### Amendments/Additional Information

# Proposed Alterations & Renovation, Hollington, The Square, Robin Hoods Bay, North Yorkshire for Ms S. Mallard.

MS S. MALLARD CLIENT  
PROPOSED ALTERATIONS & RENOVATION PROJECT  
HOLLINGTON  
THE SQUARE  
ROBIN HOODS BAY  
NORTH YORKSHIRE ADDRESS  
PROPOSED ELEVATION & SECTIONS DRAWING  
1:50 SCALE JULY 2016 DATE  
**3021M.16.04G** DRAWING NO  
Copyright Reserved

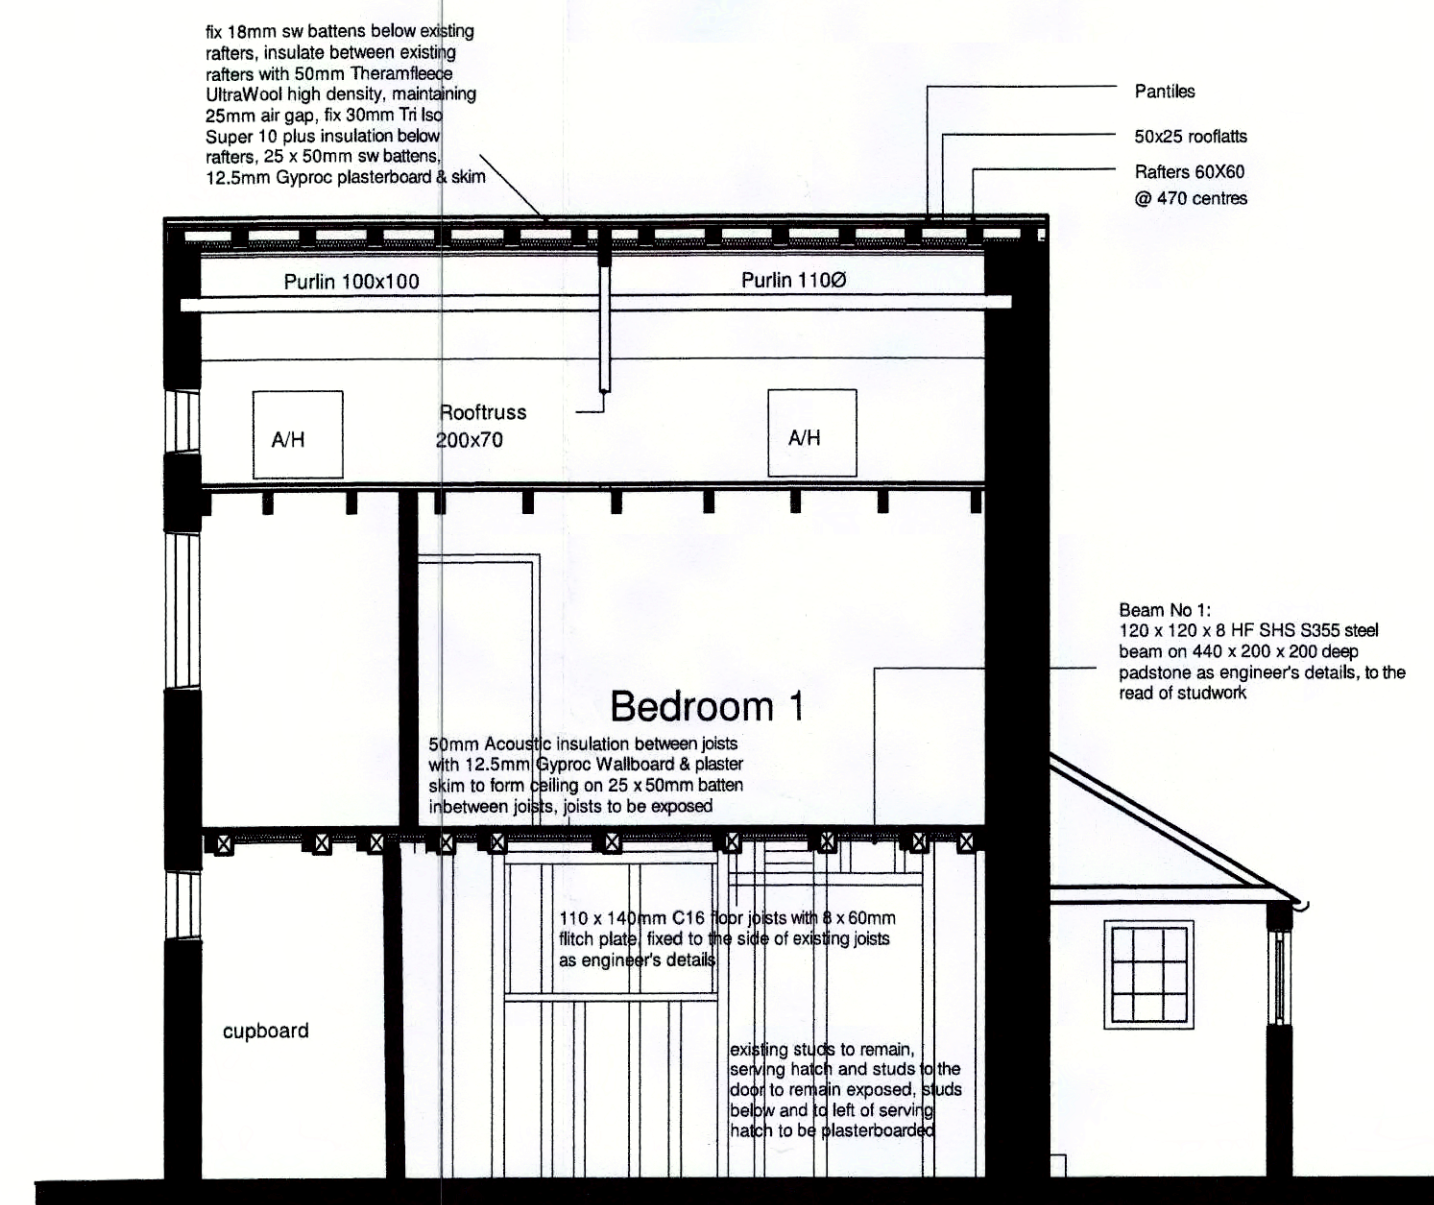
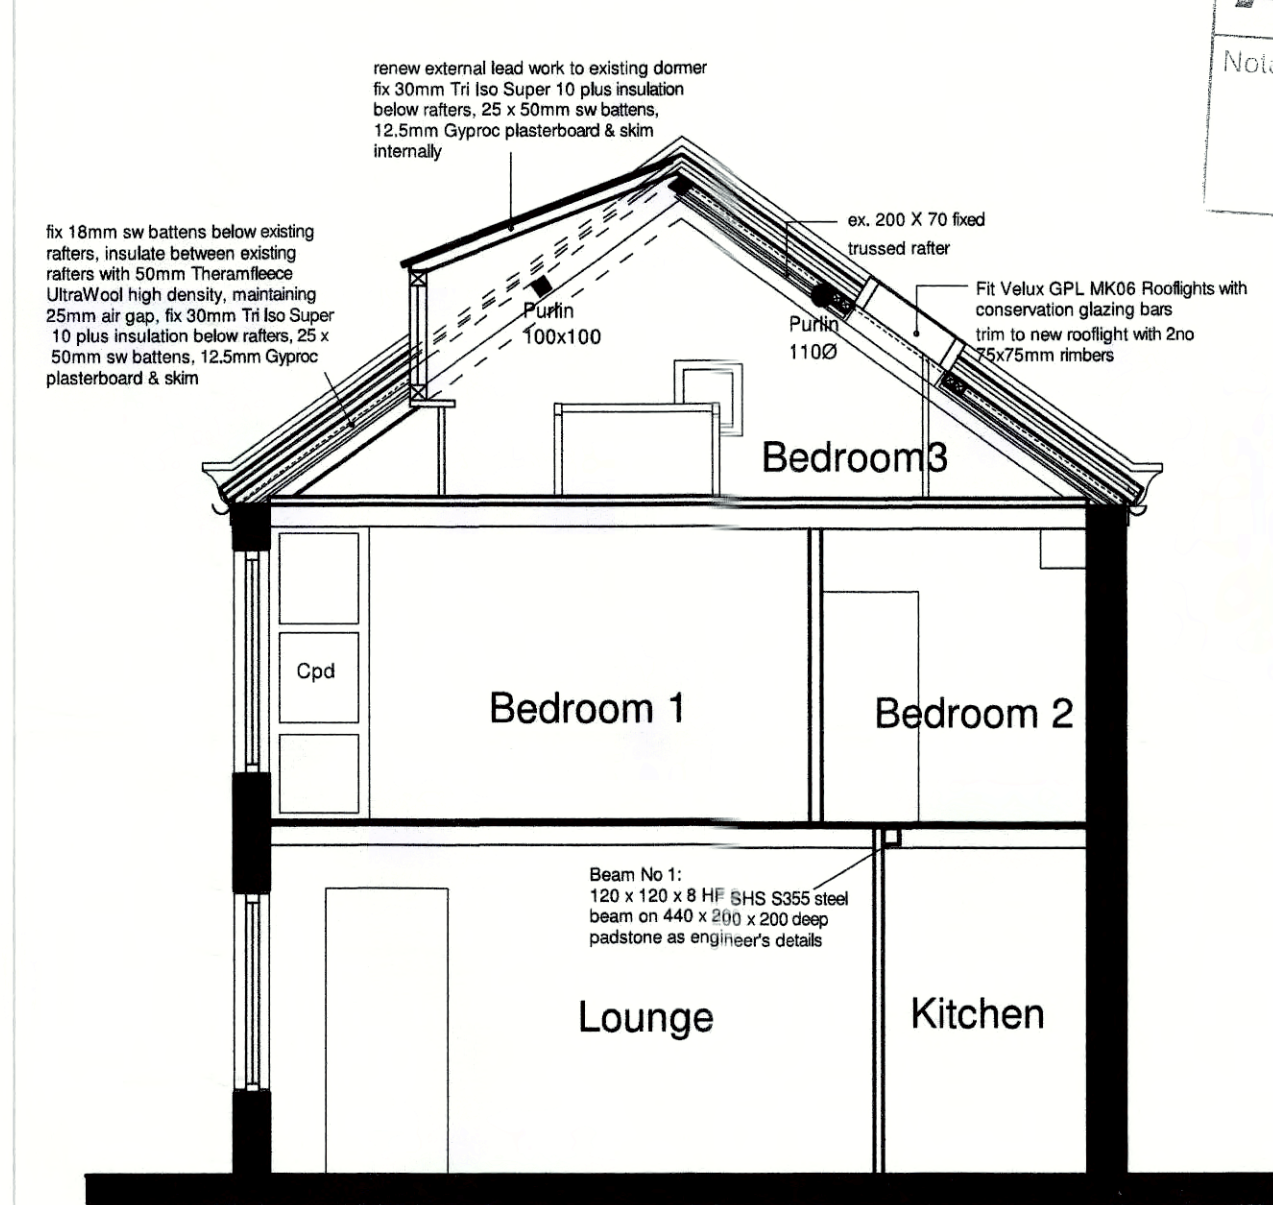
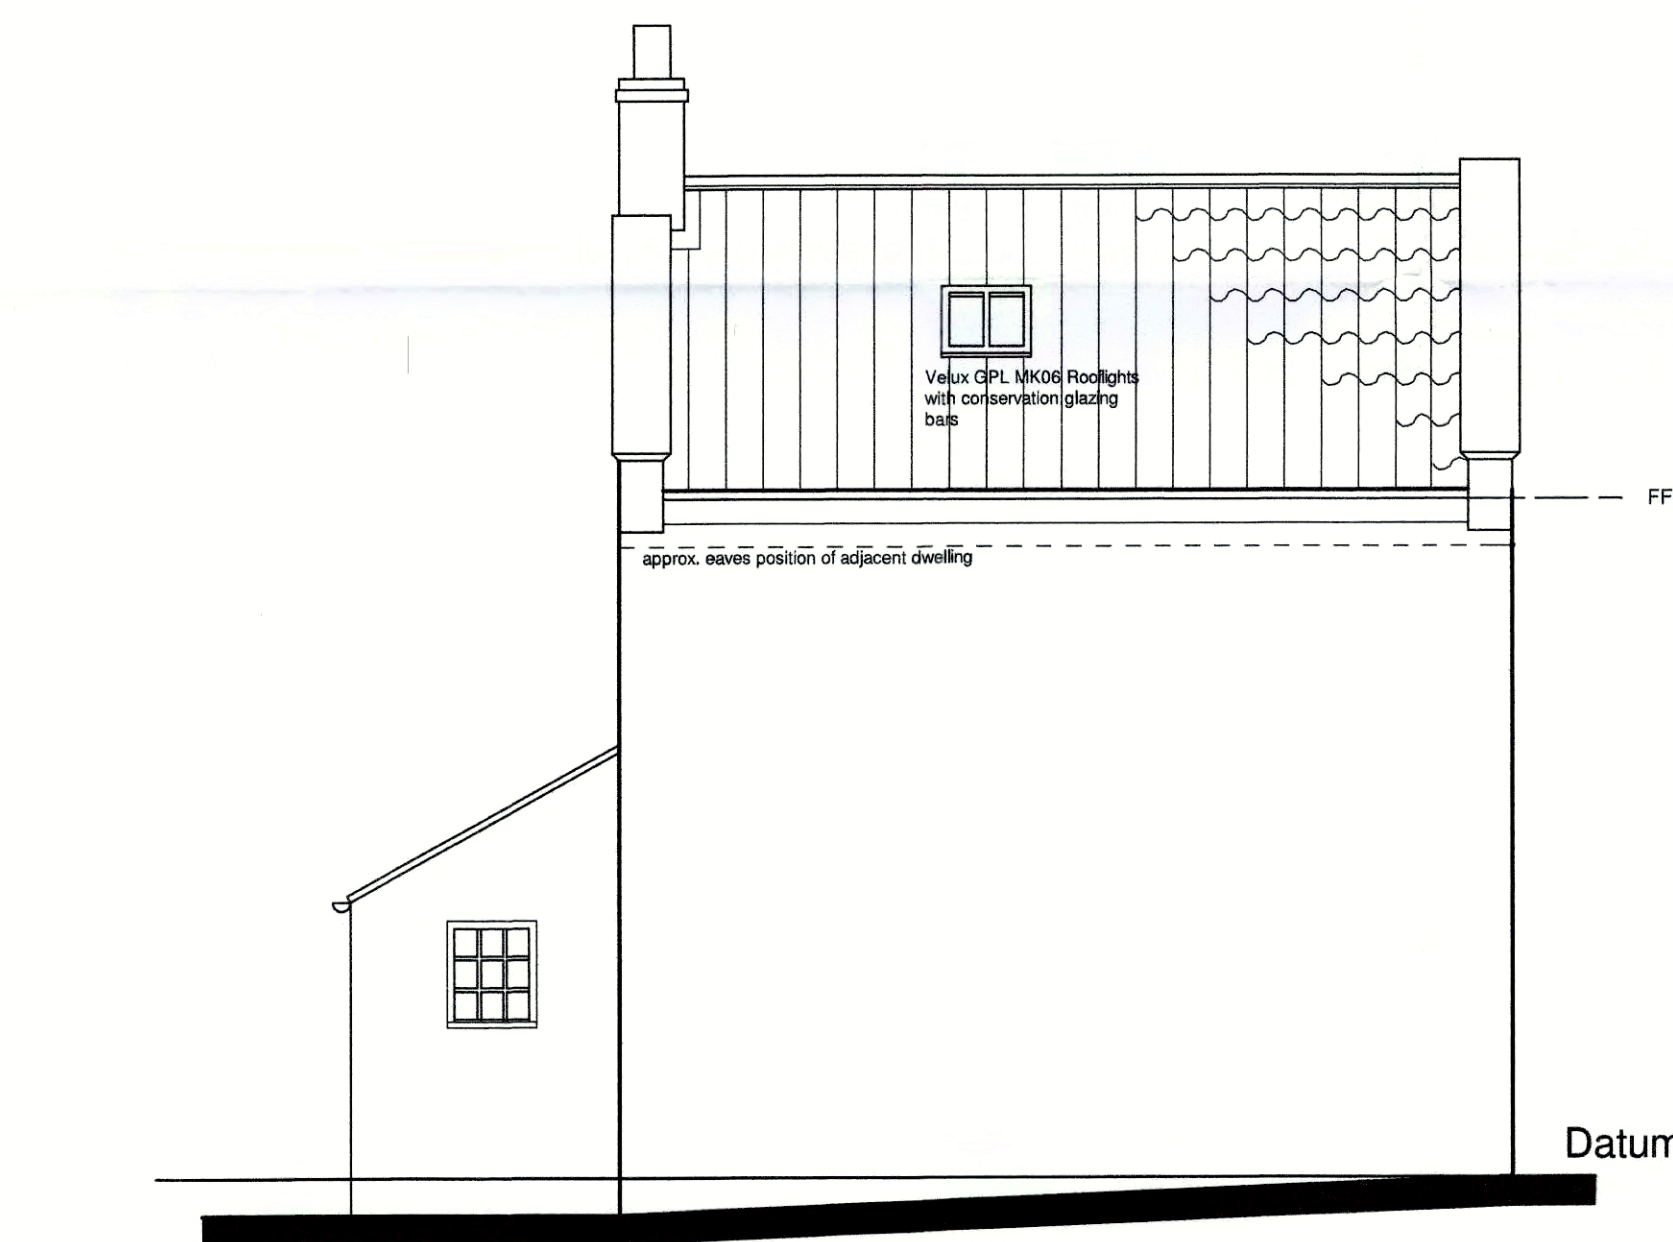
.....Dormer window amended to Yorkshire SS.  
.....Updated structural survey  
.....  
.....

Rev G: Sep 17 - Dormer Window Amended  
Rev F: Aug 17 - Notes to Studwork Amended  
Rev E: Jul 17 - Engineer's Details Amended  
Rev D: Mar 17 - Rear Elevation Added  
Rev C: Feb 17 - Notes Amended  
Rev B: Nov 16 - Notes Amended  
Rev A: Nov 16 - Engineer's Details Added
